SUBJECT: **Application for Variance**
ASTA Commercial Parking Lot - Parking Space Width & Landscape Reductions
111 S. Ocean Drive

STAFF REPORT

Location: 111 S. Ocean Drive

Figure 1 – Staff Recommended Adjustments to Site Plan

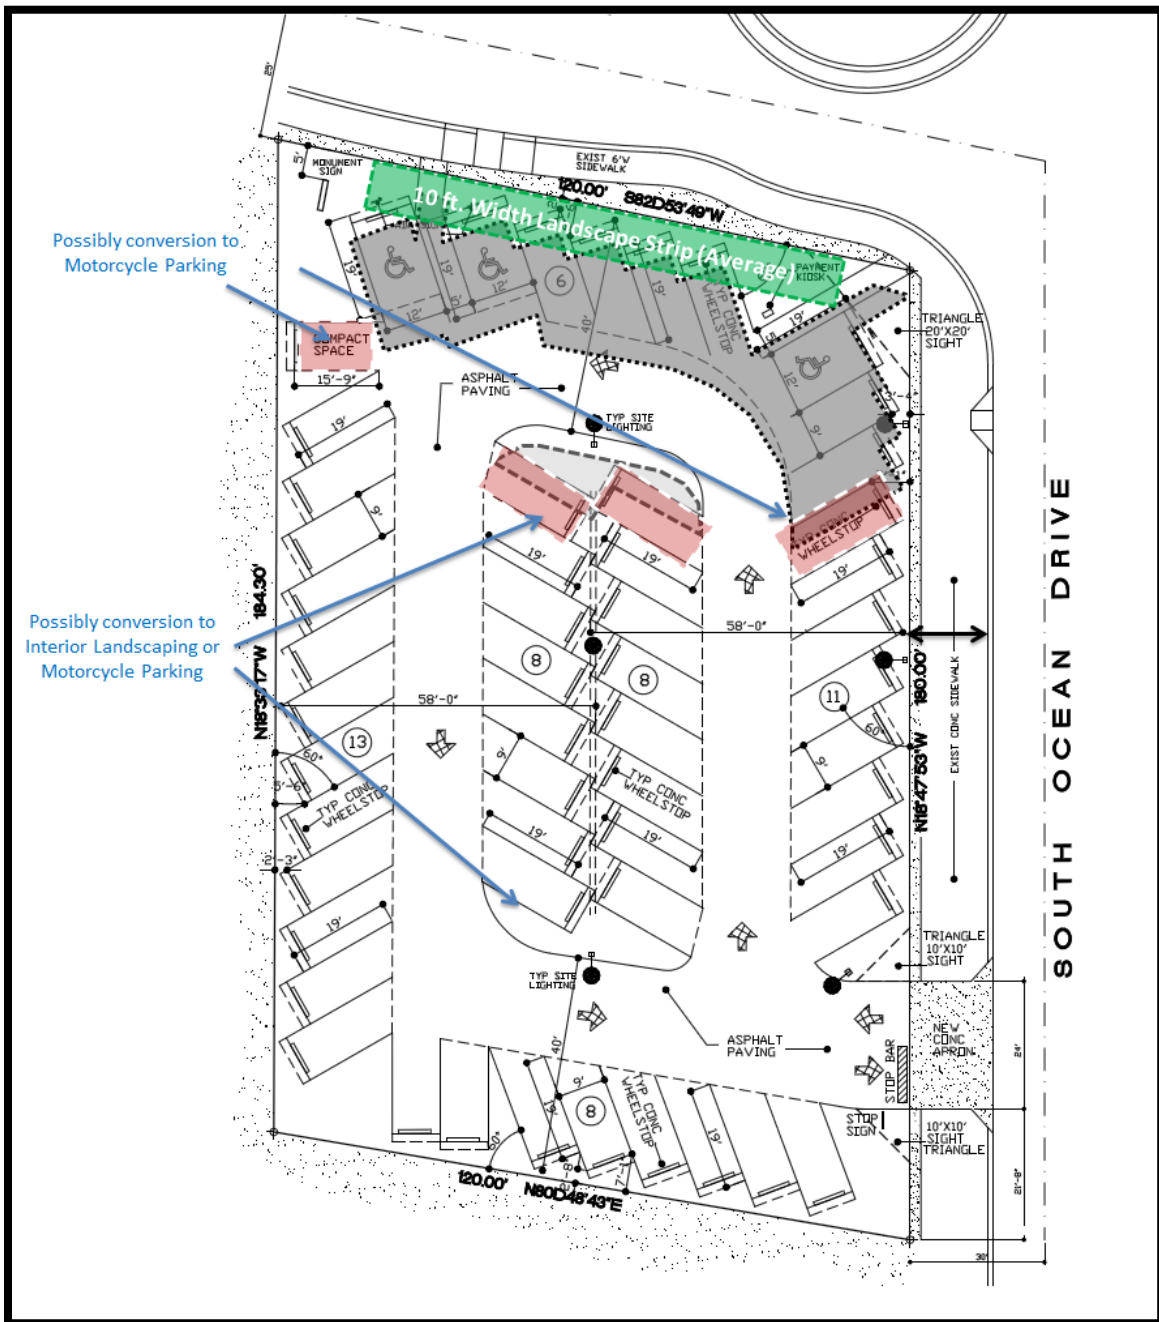
The variance deliberated by the Board of Adjustment should be consideration of the minimum variance that may make possible the reasonable use of the land. The reduction of the eastern landscape strip provides for the added capacity for an entire row of parking spaces (10-11), whereas the reduction along the northern property line only expands the quantity of parking spaces by four (4), with one of said spaces designed as a significantly compact space. The applicant retains the capacity to install the code required trees and shrubs within the remaining areas provided, which would be complimented by the existing Royal Palms present in the right-of-way. The reduction of the landscape buffer required at the northern property line only renders a four (4) parking space advantage, whereas the reduction places a line of vehicle parking spaces towards traffic traveling towards the Jetty Park Area. The reduction of four (4) parking spaces would provide necessary space to meet

the required landscape at the northern property line and interior vehicular use area. A conceptual demonstration of this adjustment is provided below in Figure 1.

- Elimination of four (4) parking spaces noted in red in order to provide a 10 ft. (average) landscape buffer along the northern property line, or primary entrance to the Jetty Park area
- Minor of Parking area south, and further expanding the interior landscape area to meet minimum requirements.

4) The site plan is amended to provide a landscape strip along the northern property line which averages a minimum width of ten (10) feet and the required interior vehicular use area landscaping. This adjustment further provides resolution to Technical Review comments #2 & #3 provided by the Engineering Department on April 17th, 2017 (attached).

Figure 2 – Interior Property Line Exhibit – Oculina Bank & Proposed ASTA Parking Site

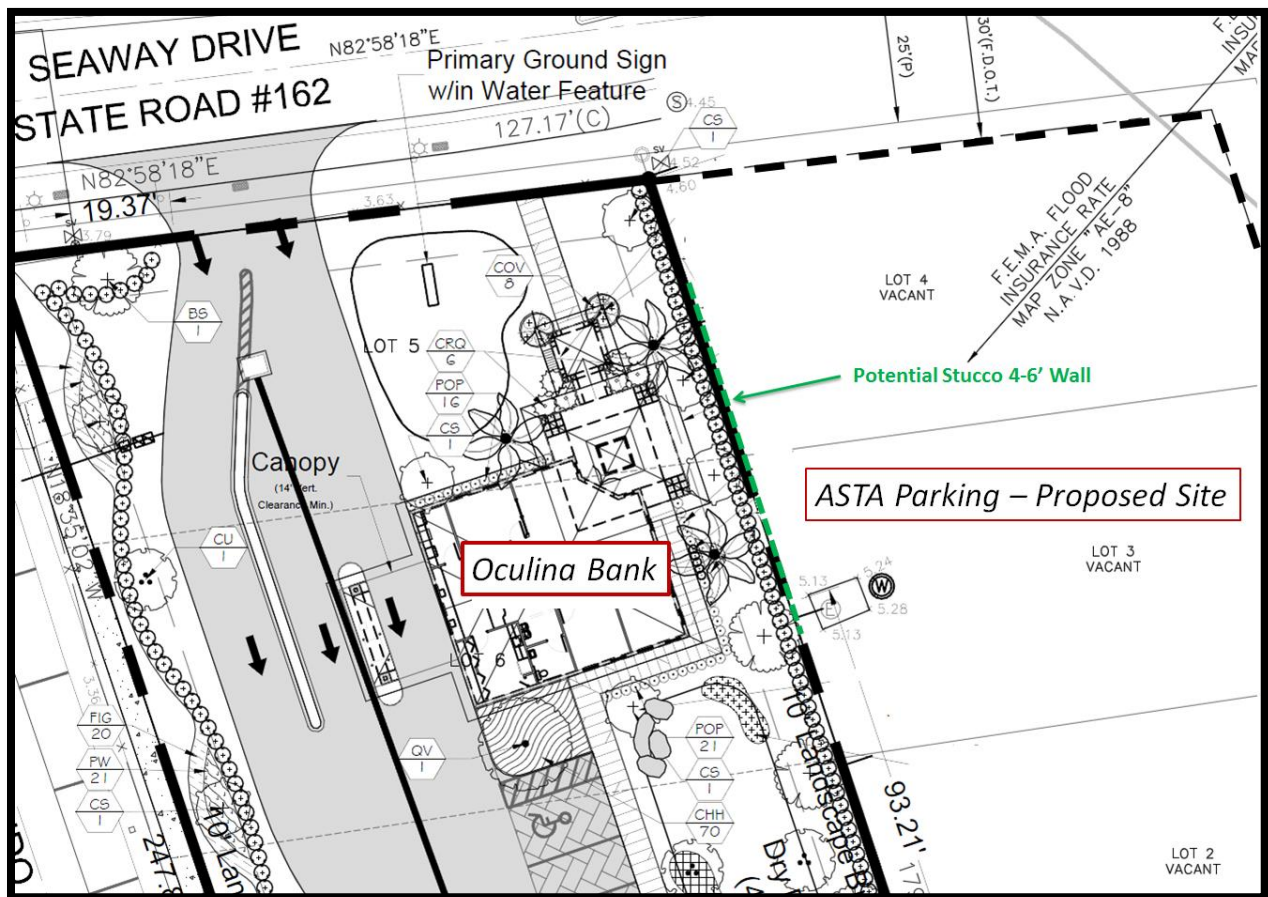
In addition to the recommended landscaping area increases with the aforementioned adjustment, staff recommends the integration of plant materials within the western landscape strip that would provide greater visual and noise relieve from the intended development, seeking to mitigate the reduced landscape area along this property line. The Board of Adjustment may consider requiring a section of this buffer to include a decorative wall adjacent to the entrance of the neighboring commercial structure.

- Consideration of a 4-6ft. tall decorative wall section to mitigate proposed landscape buffer reduction as Oculina Bank’s front entrance is in close proximity to the landscape area sought for reduction.
- Integration of a 6ft. tall hedge along the west property lines to mitigate the reduced buffer width.

3) The landscape plan provides the planting, and appropriate irrigation, of a vegetative hedge along the west property lines, which has the capacity to grow to form a 6ft. tall buffer to mitigate the reduction in landscape strip width adjacent to these property lines. An section of the buffer may consist of a decorative wall to provide separation of the proposed parking area from the entrance corridor of Oculina Bank to the west.
